Re: **1225 Centre Street – MassDEP File Number 006-1573**

RE: SUBMITTAL – Response to review comments for 1225 Centre Street

RE: SUBMITTAL – 1225 Centre Street Supplemental Narrative

STORMWATER MANAGEMENT PLAN

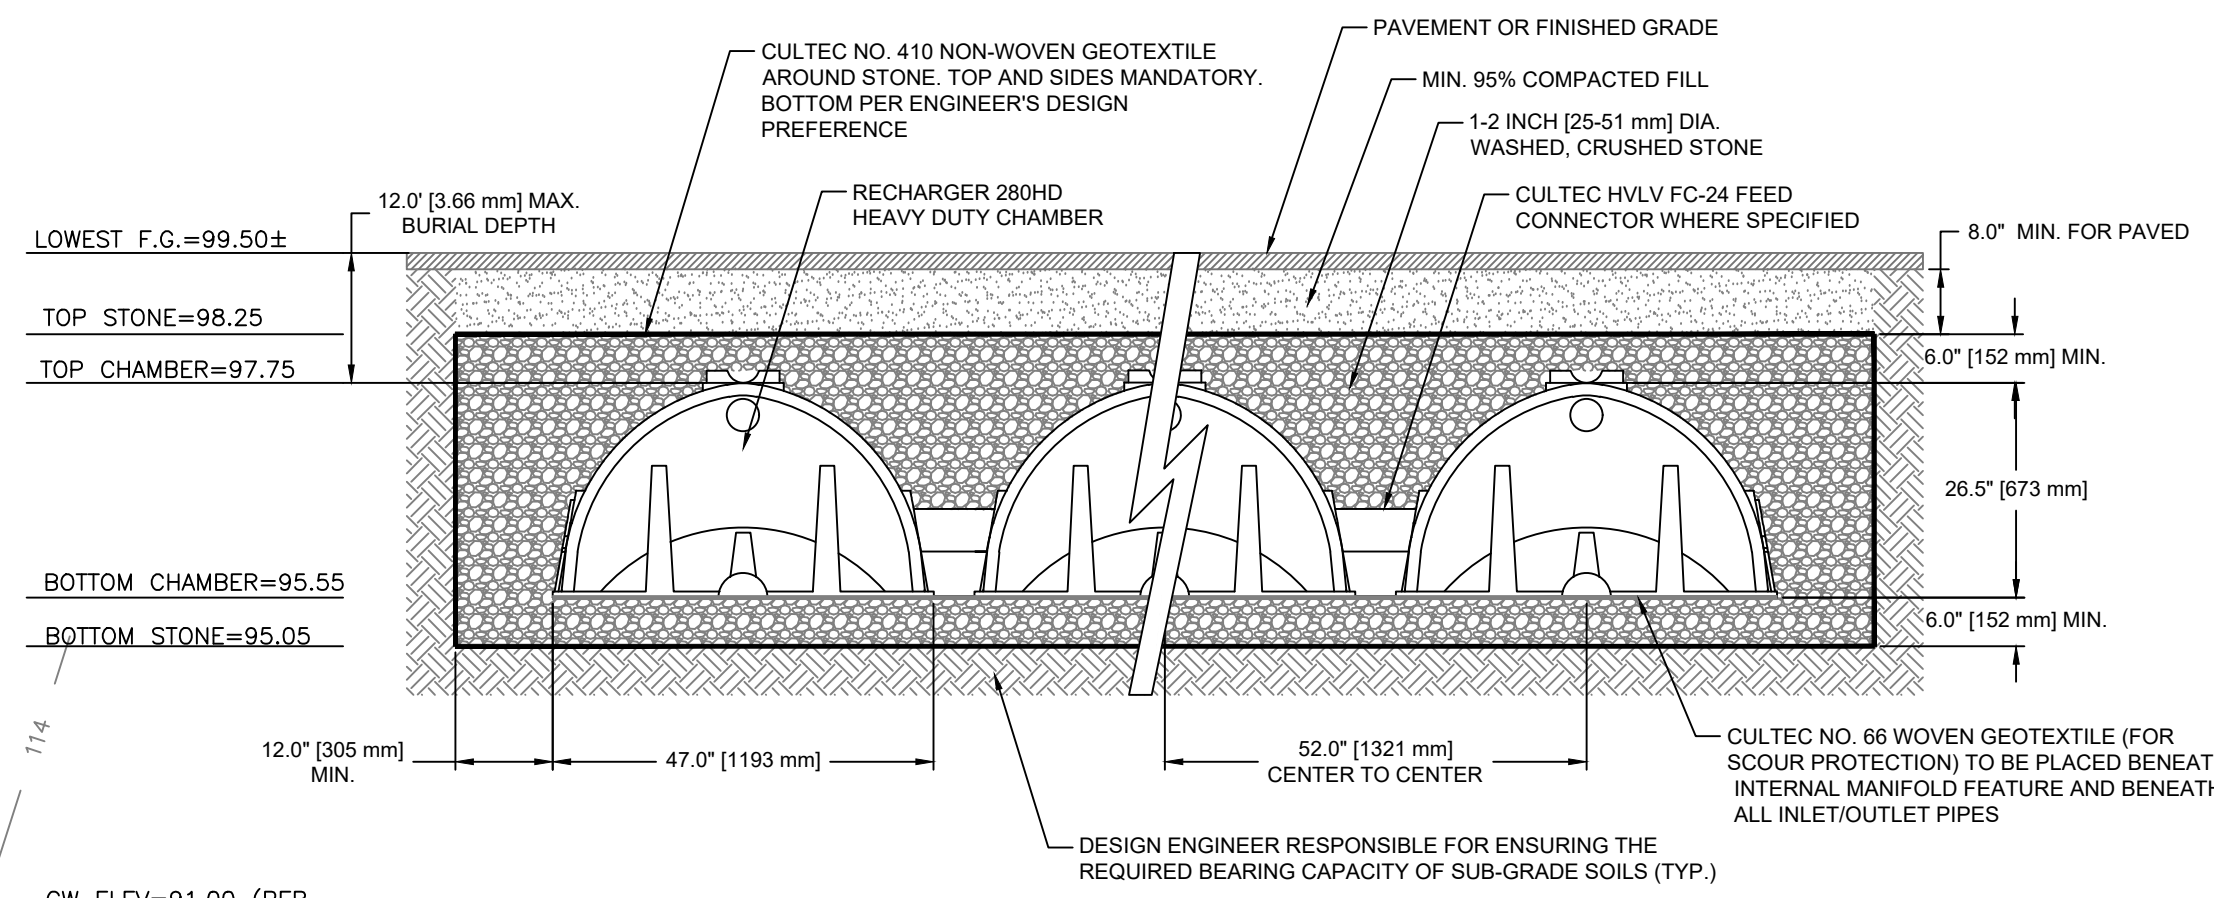
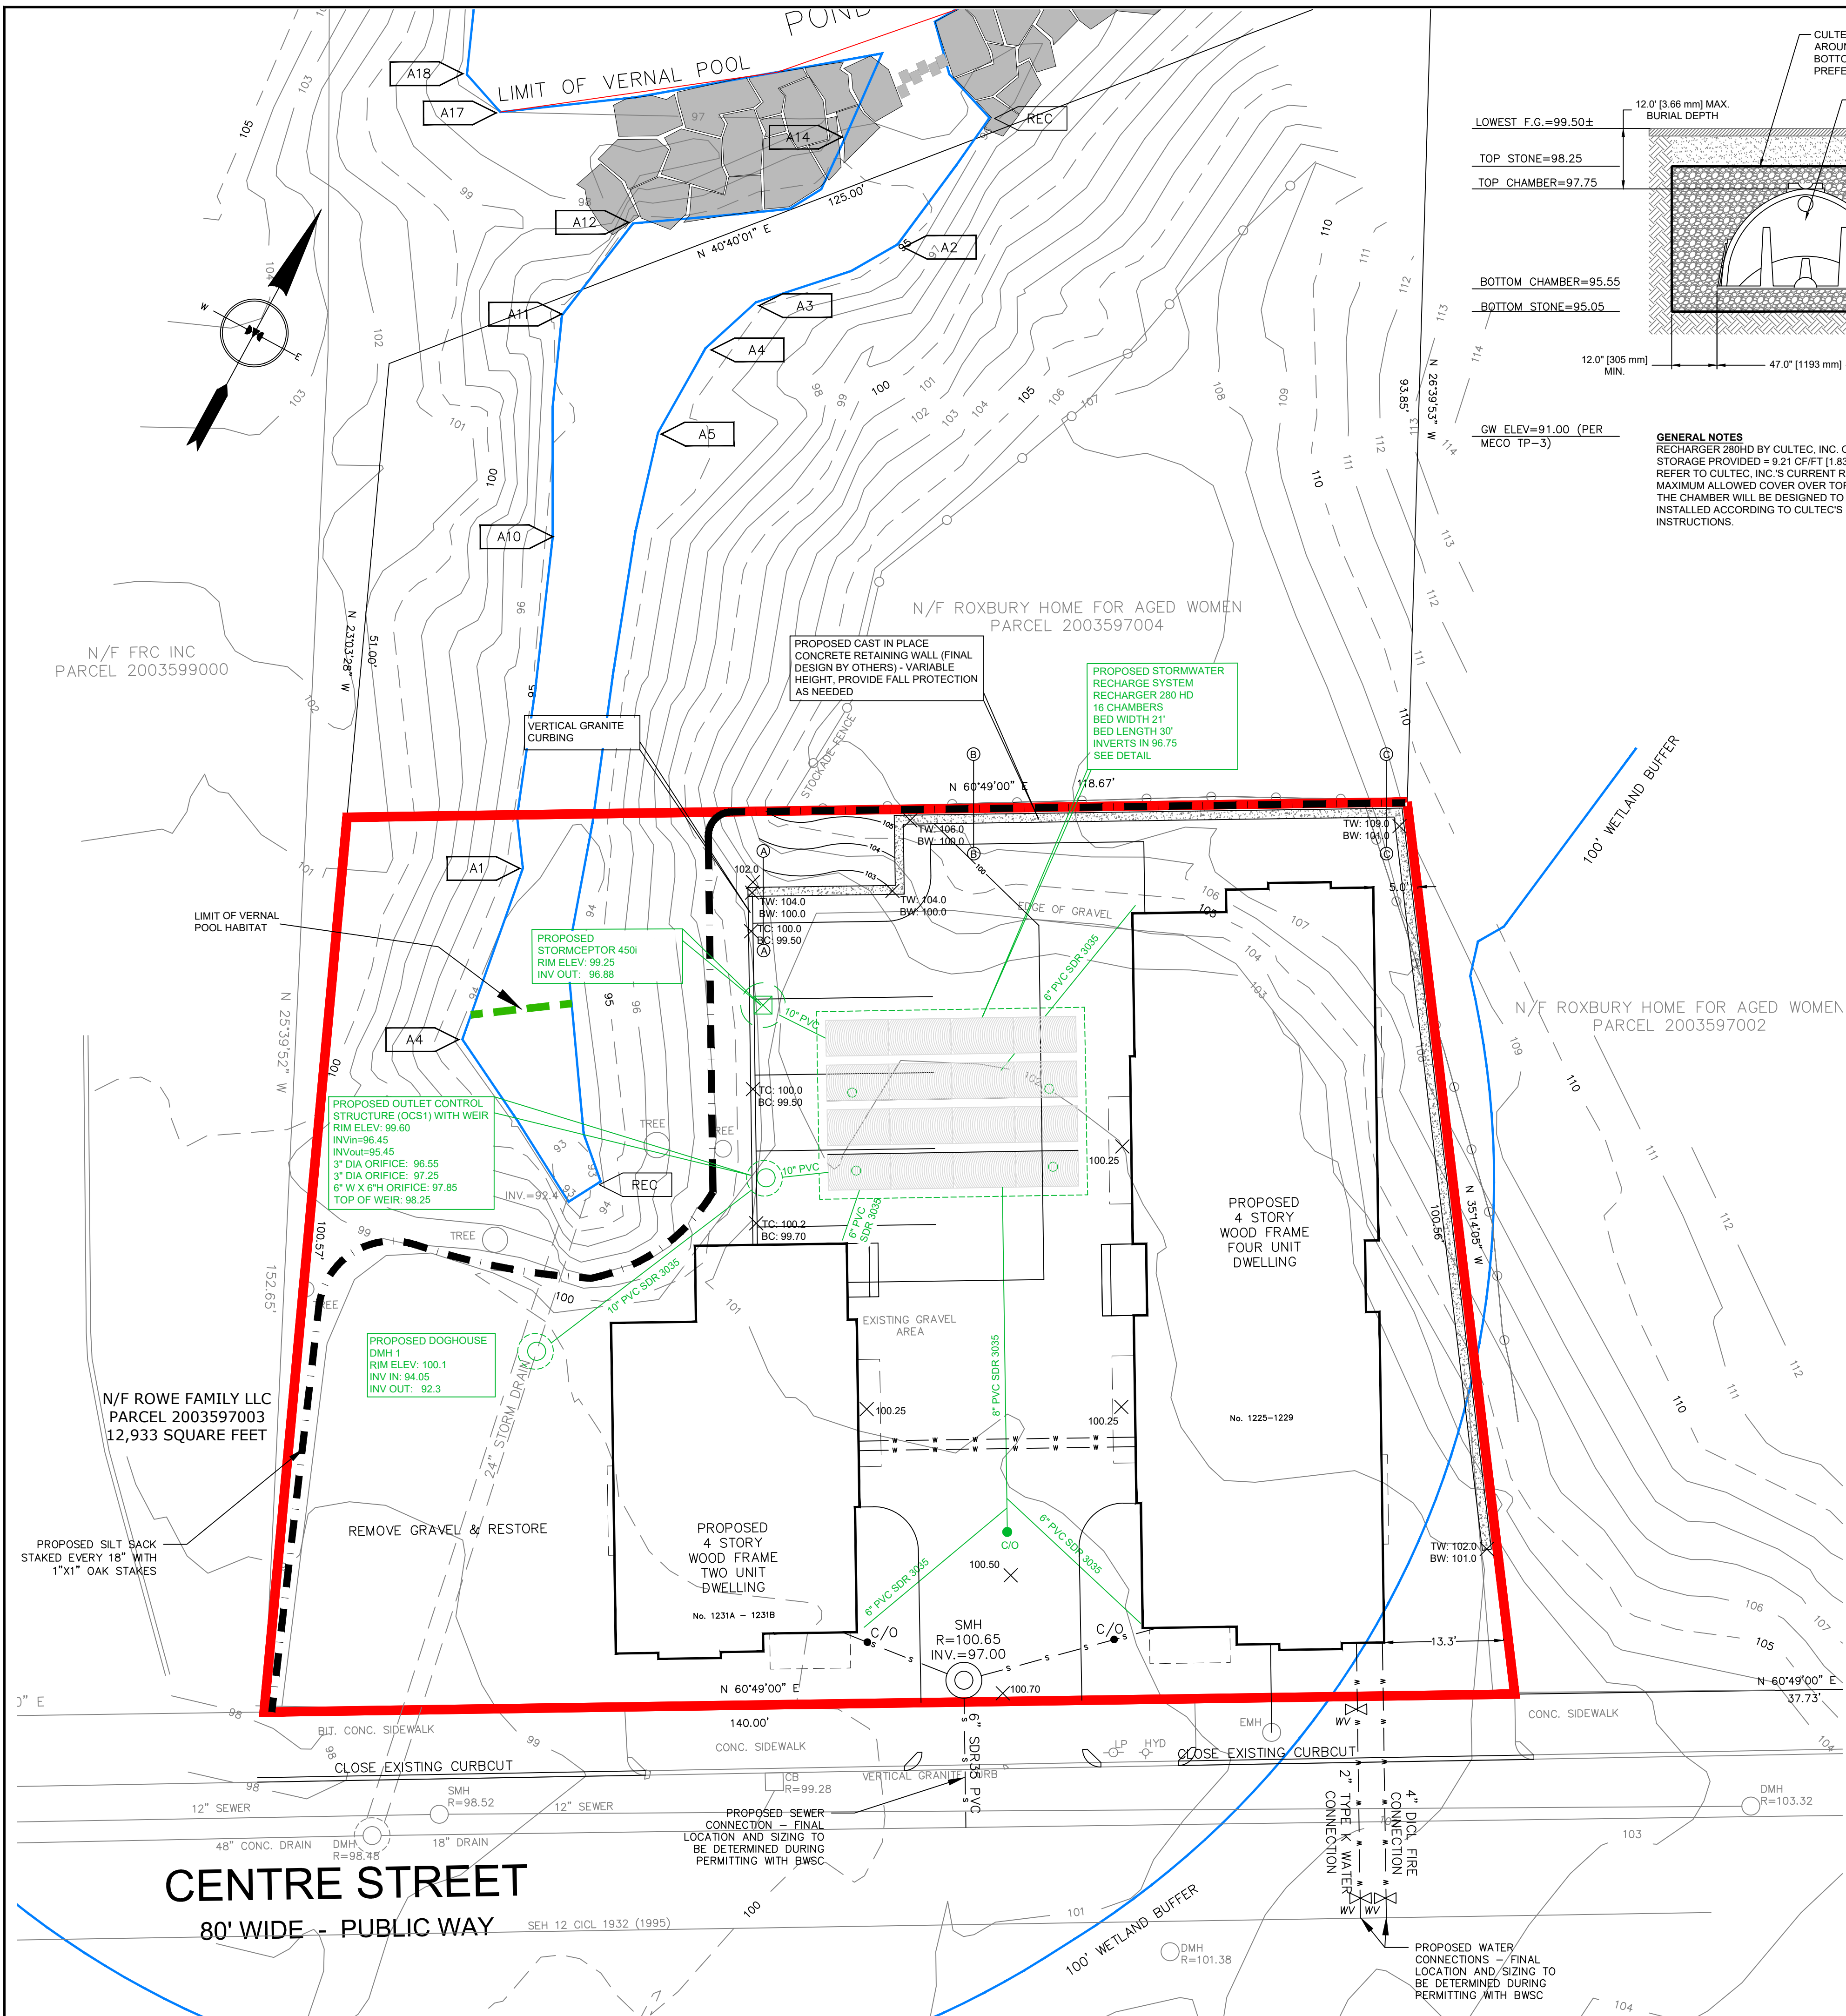
4. *Revised stormwater plans to include a stormwater overflow system to prevent flood and flooding when the infiltration unit is at capacity. Said plans shall be stamped by a licensed engineer.*

8. *A new stormwater outfall is proposed and will serve as an overflow from the proposed recharge system. Additional detail should be provided for this outfall, including the elevation, proximity to the pond/wetland boundary, and stabilization measures. These details are necessary to ensure there will be no proposed work within the wetland and that the area will remain stabilized after construction.*

There can be no discharge of stormwater into a vernal pool.

Please find the revised stormwater report attached. The site plan has been revised to show an overflow to a proposed manhole over the existing drain line as requested by BWSC.

The overflow from the infiltration system has been relocated to a proposed drainage manhole over the existing outlet pipe for the intermittent stream. This location was requested by BWSC and has less impact on the resource area.

The Plan has been revised to discharge the infiltration overflow directly into the existing drainage pipe.

UNDERGROUND INFILTRATION AREA
 NOT TO SCALE

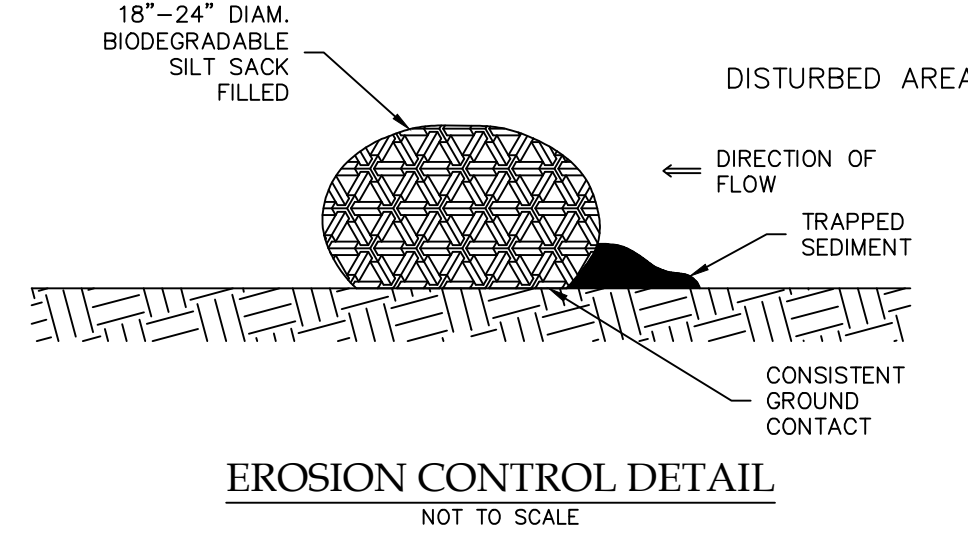
10. *The storage volume of the proposed recharge system appears to be exceeded beginning in the 2-year storm event. This is indicated by the peak storage elevation in HydroCAD being higher than the top of stone noted in the detail on the Site Plan. The size of the system may need to be increased to provide additional volume capacity.*

There may have been a conflict in the HydroCAD data and the plan data with regards to the system elevation, this error has been resolved as a result of the revised calculations.

REINFORCED CONCRETE WALL SECTIONS
 WALL DESIGN IS SCHEMATIC.

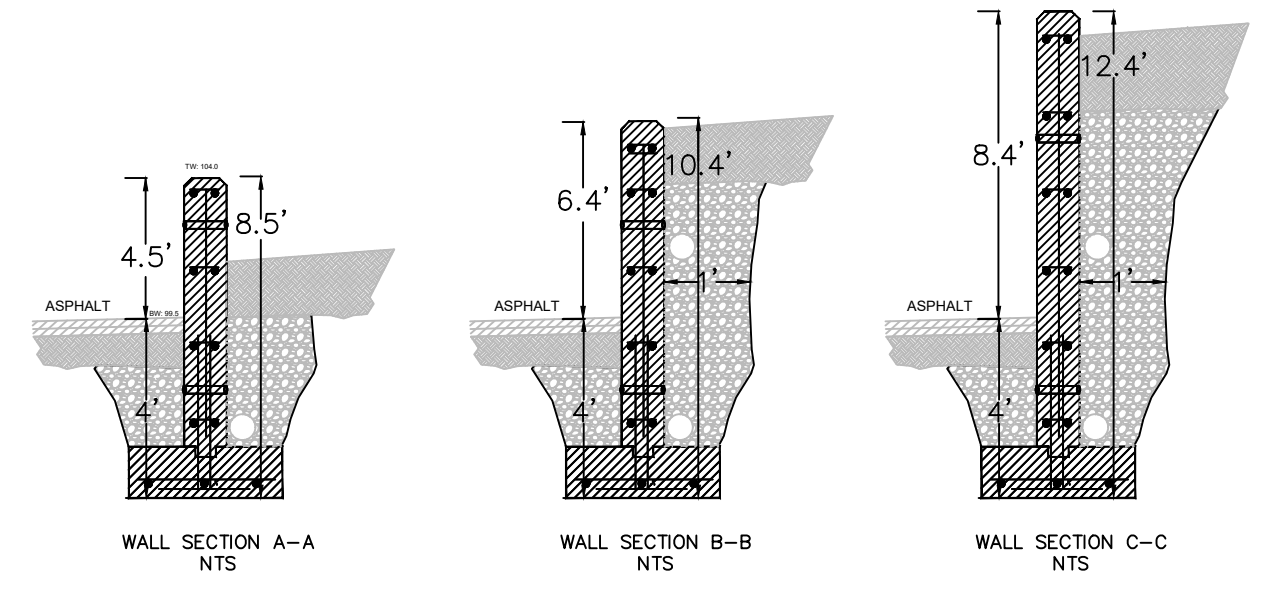
1. Site Plans detailing the retaining wall and proposed fill;

2. Narrative on the impact of the slope of the bank during construction (specifically of the retaining wall) and how the applicant plans to mitigate those impacts. Said narrative should also detail how the applicant will get equipment out and around those areas to perform work.

The Site Plan has been revised to significantly reduce the amount of retaining wall required, specifically in the area abutting the existing intermittent stream. The reduced length of wall will vary in height from approximately one foot to seven feet. The wall is shortest in the area above the bank. In this section modular block will be used requiring minimal excavation and a gravel foundation. Where the wall is above three feet in height, toward the right rear corner of the property, a cast in place concrete section will be built.

As a result of the revised parking area layout, there will be no excavation for a proposed retaining wall between the edge of parking and the resource area. The proposed retaining wall will consist of a cast-in-place concrete retaining wall with a four-foot deep subsurface footing, the exposed portion of the retaining wall will vary dependent on depth. To excavate for the retaining wall, construction equipment will enter from Centre Street through an existing curb cut. All work for the proposed retaining wall will be conducted from the existing compacted gravel areas and at no time will there be equipment traversing up or down the existing bank.
